ADDENDUM No. 1 TO THE CONTRACT DOCUMENTS

Project: UMC Laydown Area

Addendum Issue Date: September 25, 2018

Issued By: Seth Anderson
PND Engineers, Inc.
1506 West 36th Avenue
Anchorage, Alaska 99503

TITLE: **EXISTING CONDITIONS AND SURVEY CONTROL**

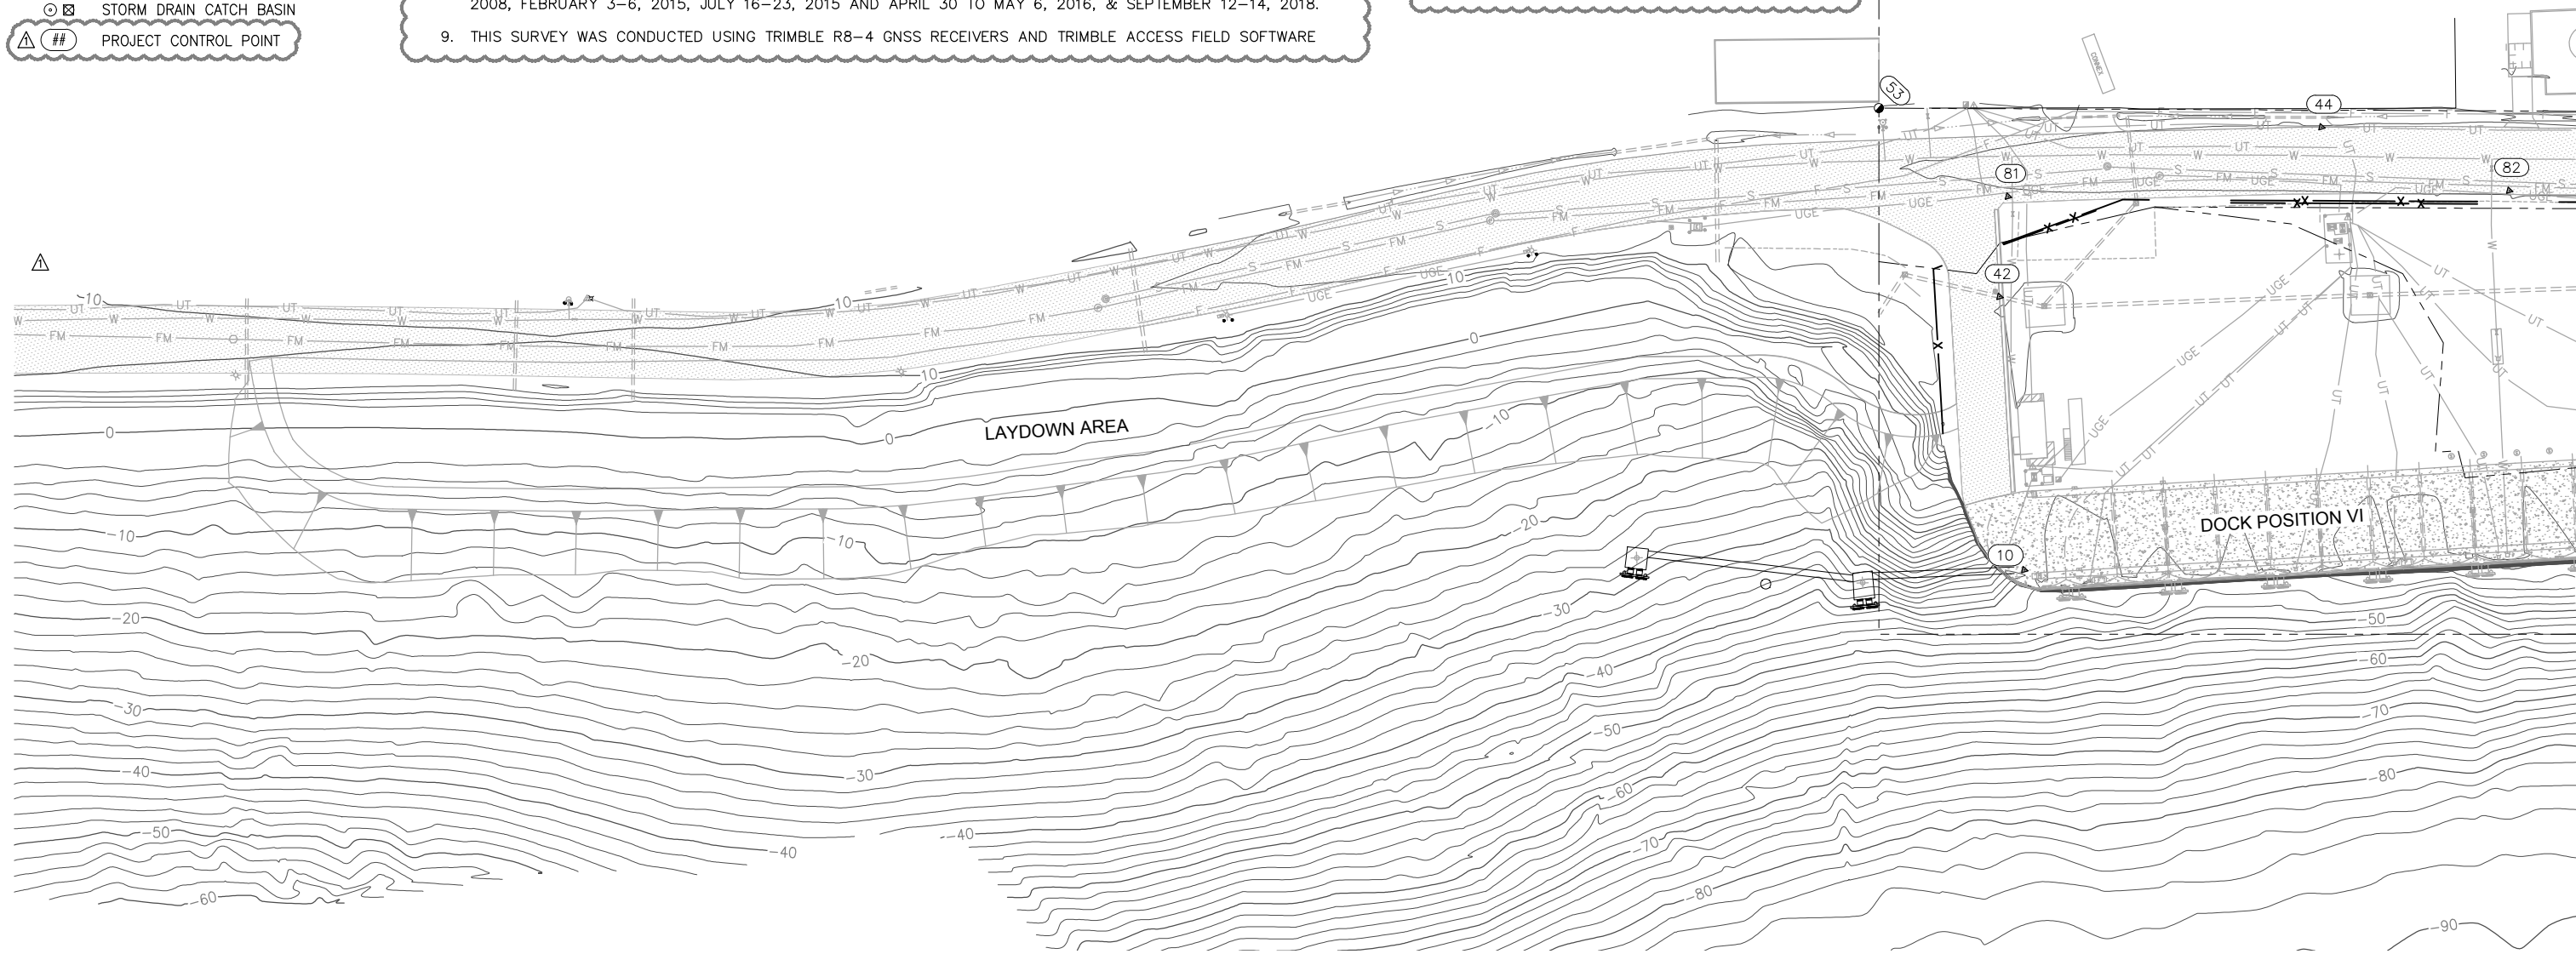
Replace Sheet 3 of 5, previously issued in the IFB drawing set dated September 5, 2018, with the updated Sheet 3 of 5 (rev 1) included as an attachment to this addendum. Revisions made to Sheet 3 of 5 are denoted with a revision triangle and revision cloud. In addition, the existing ground contours have been updated to reflect the most recent survey conducted September 12 – 14, 2018.

TITLE: **SITE PLAN**

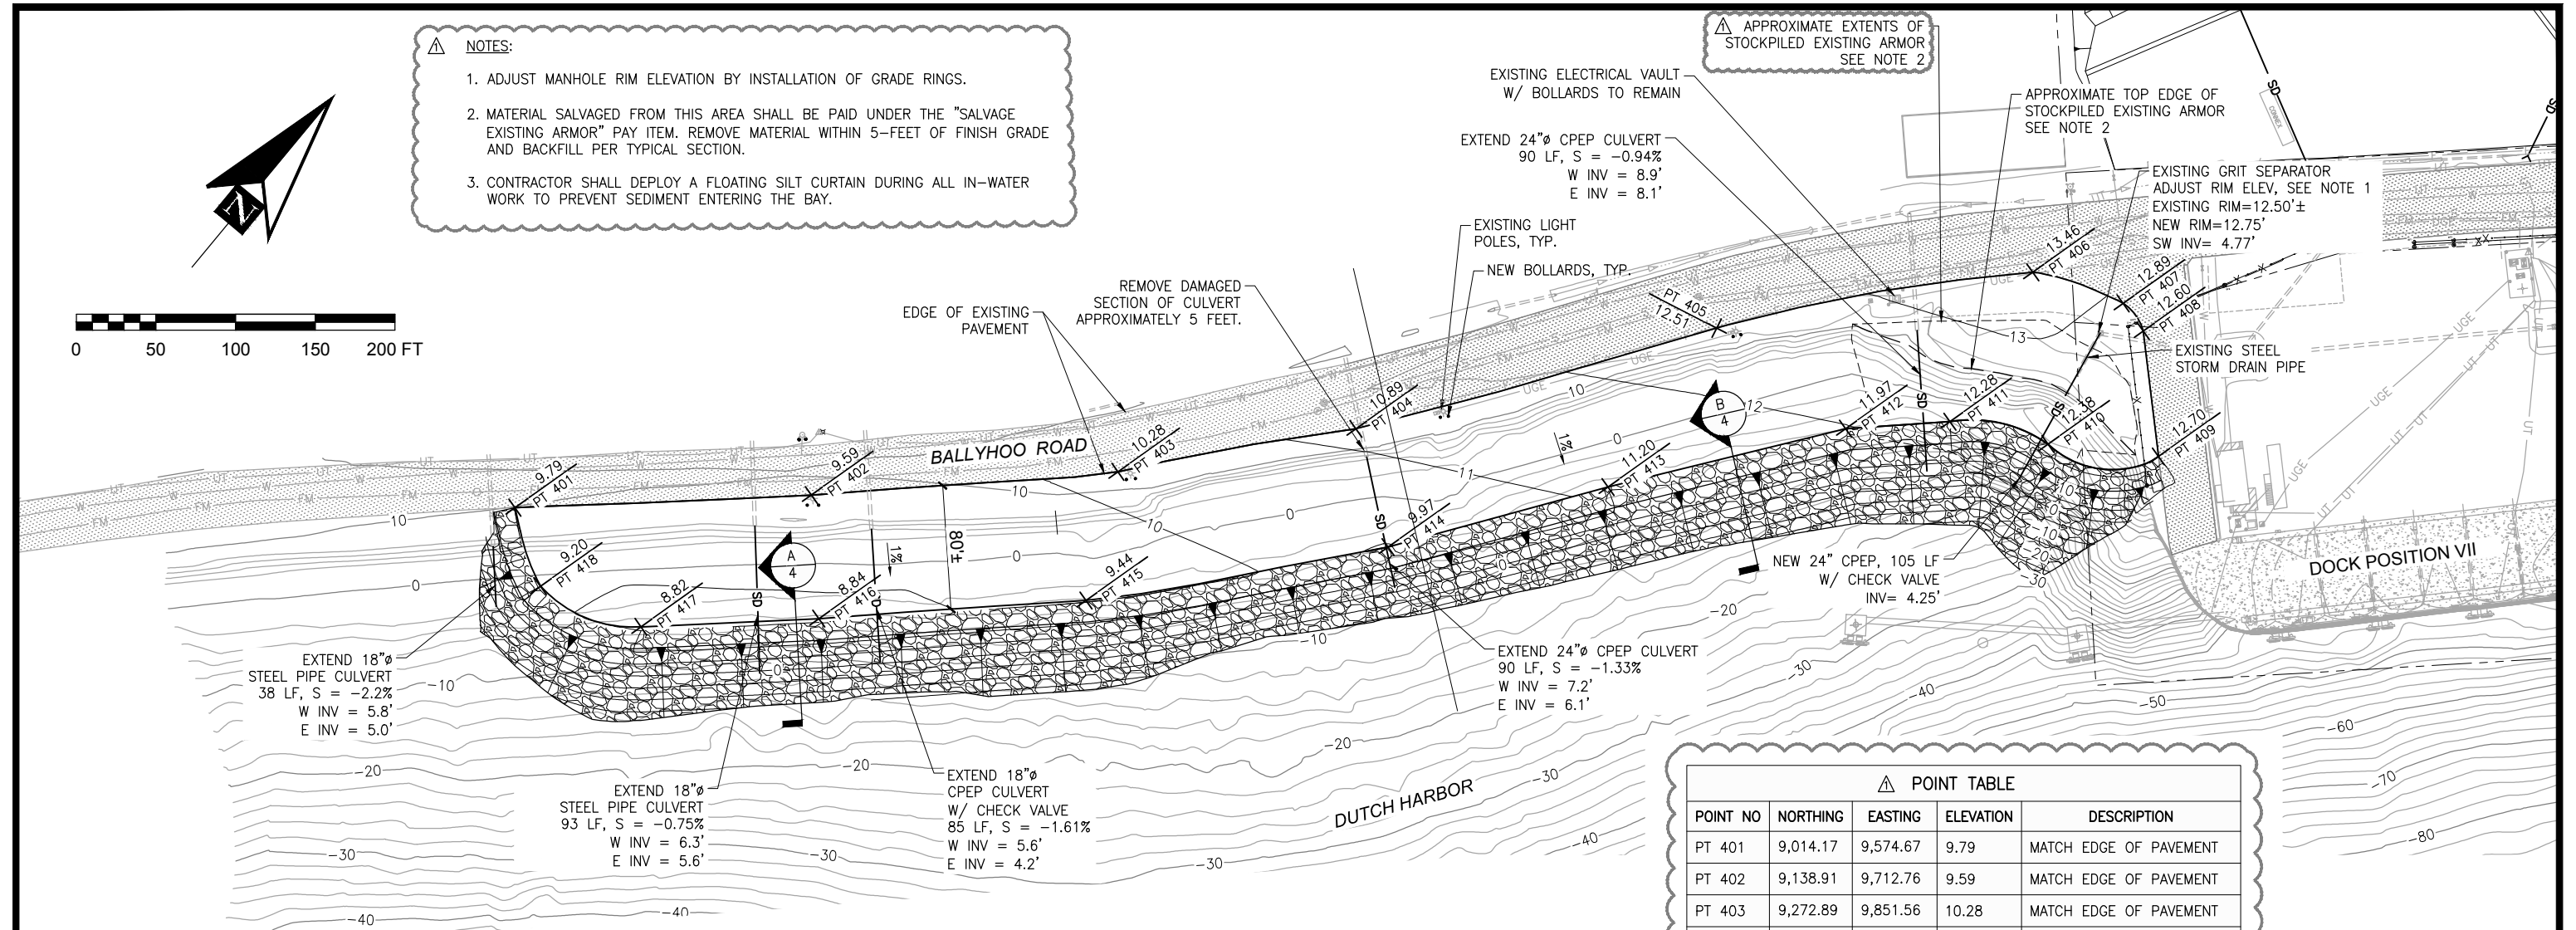
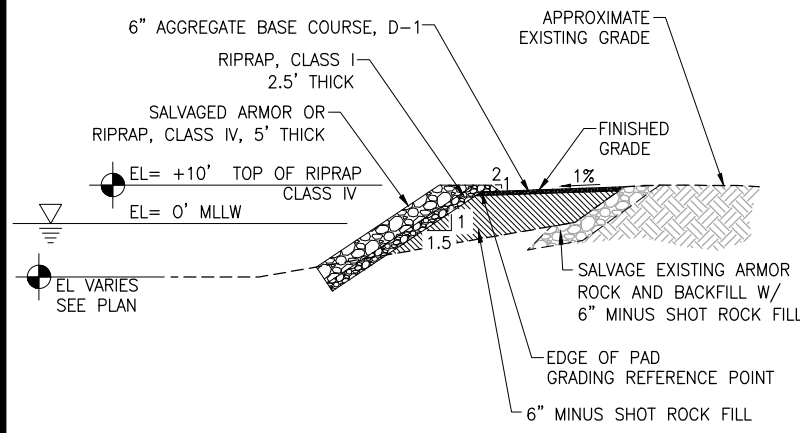
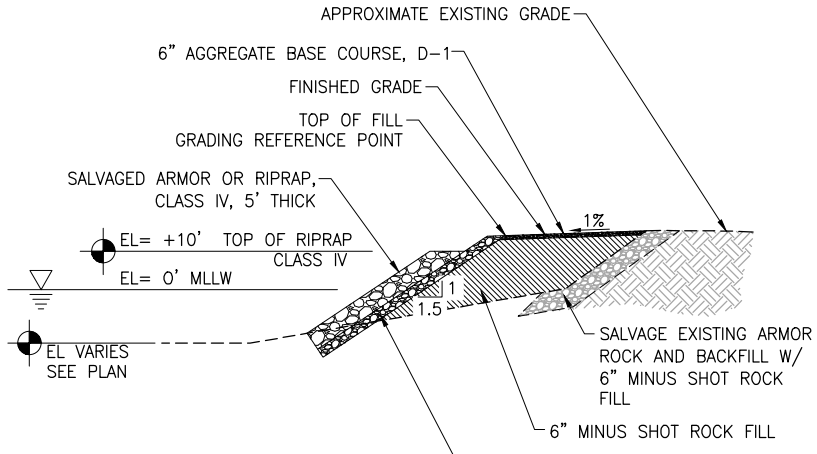
Replace Sheet 4 of 5, previously issued in the IFB drawing set dated September 5, 2018, with the updated Sheet 4 of 5 (rev 1) included as an attachment to this addendum. Revisions made to Sheet 4 of 5 are denoted with a revision triangle and revision cloud. In addition, the existing ground contours have been updated to reflect the most recent survey conducted September 12 – 14, 2018.

RIPRAP STOCKPILE SURVEY
 UMC BALLYHOO EXTENSION
 SPIT STOCKPILE SURVEY

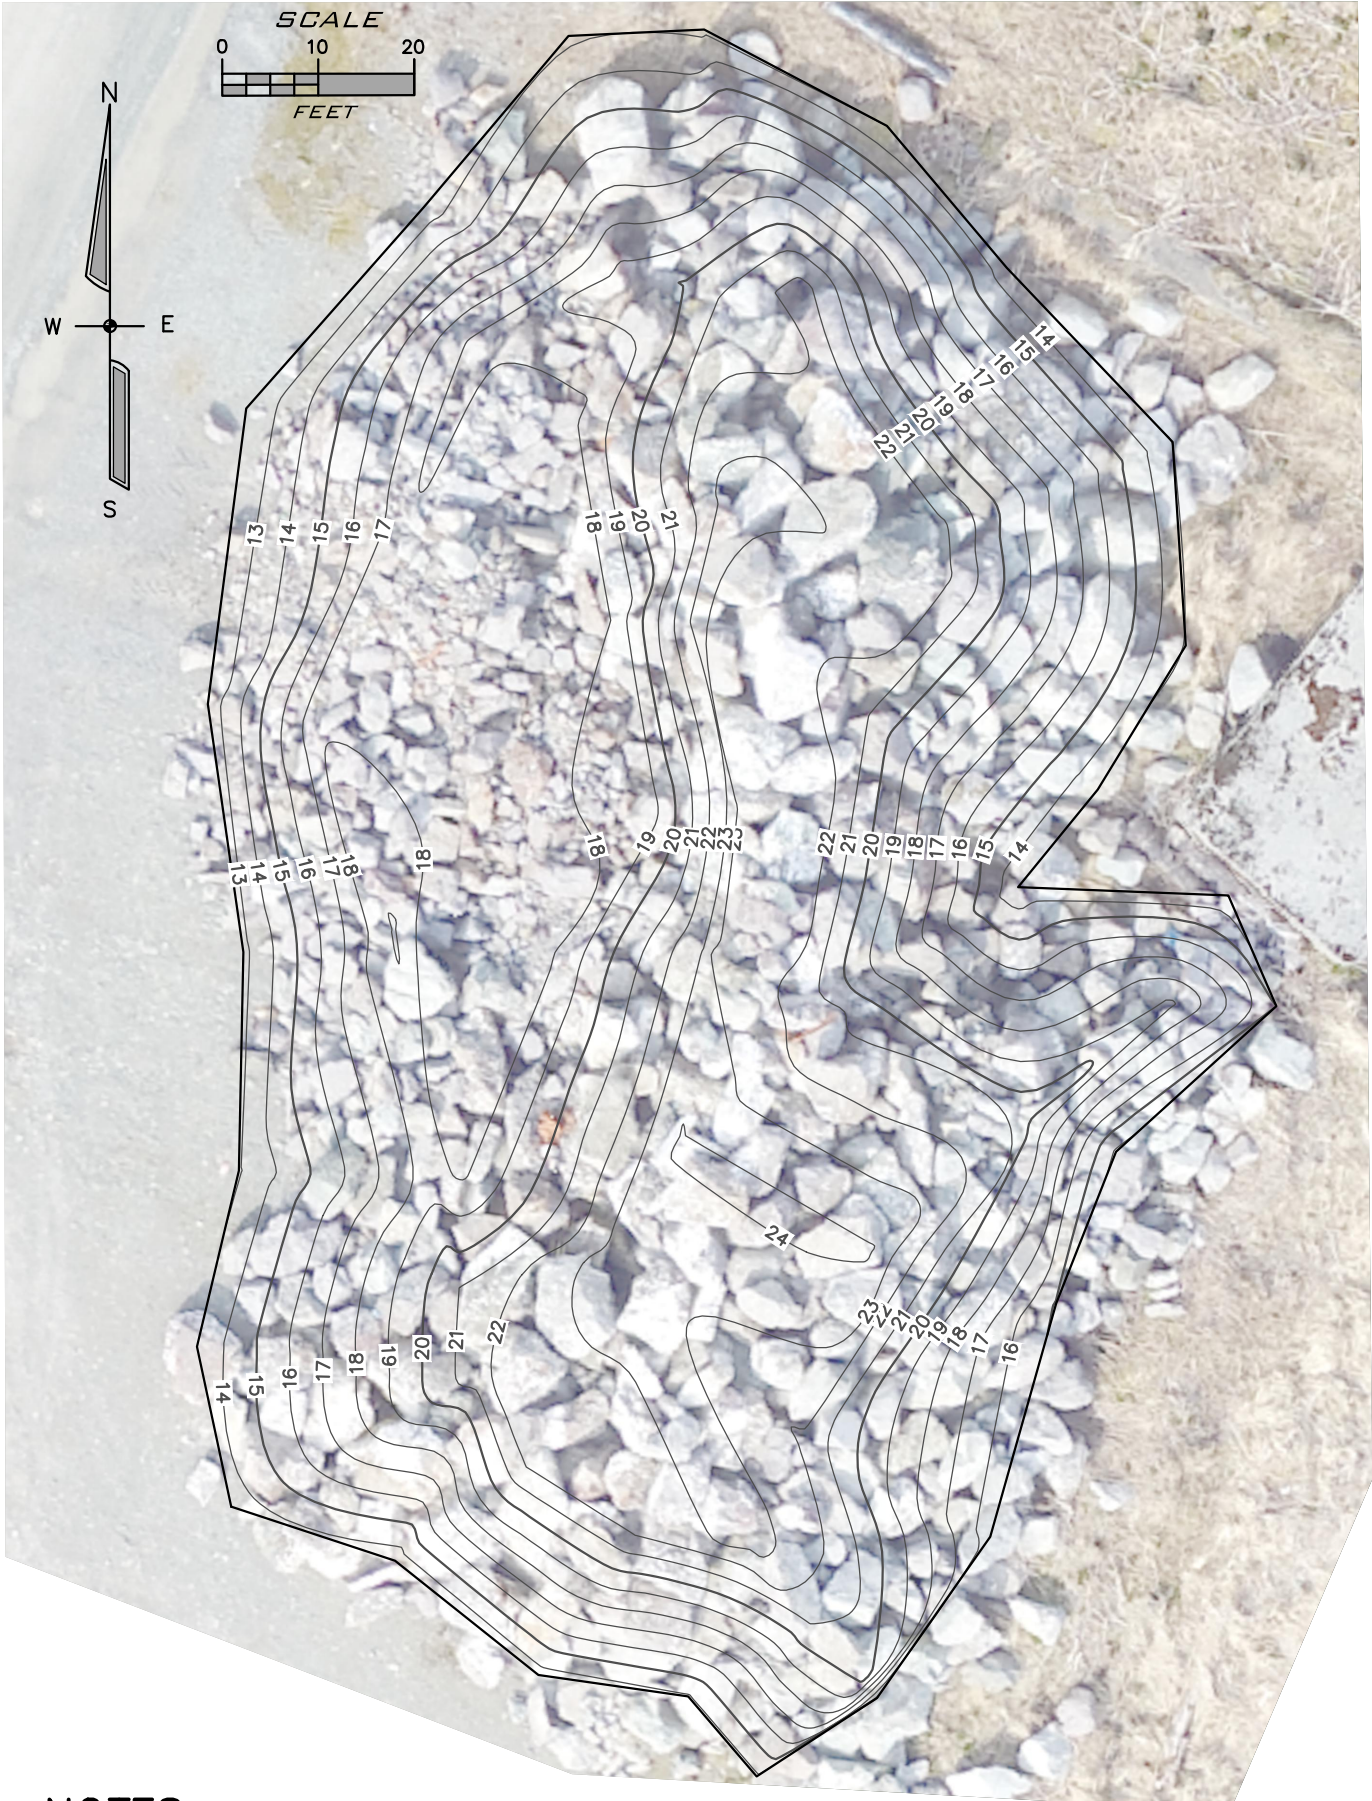
This Land XML file is included for Bidder efficiency only and is an un-official document. It is the Bidder's responsibility to verify the accurateness of the electronic information using the Drawings and conditions observed in the field. Official topographic surface data for the UMC Laydown Area is provided in the Drawings on sheets 3 of 5 and 4 of 5. Additionally, the riprap stockpile located on the Spit at the end of Ballyhoo Road is depicted in the figure attached to this addendum.
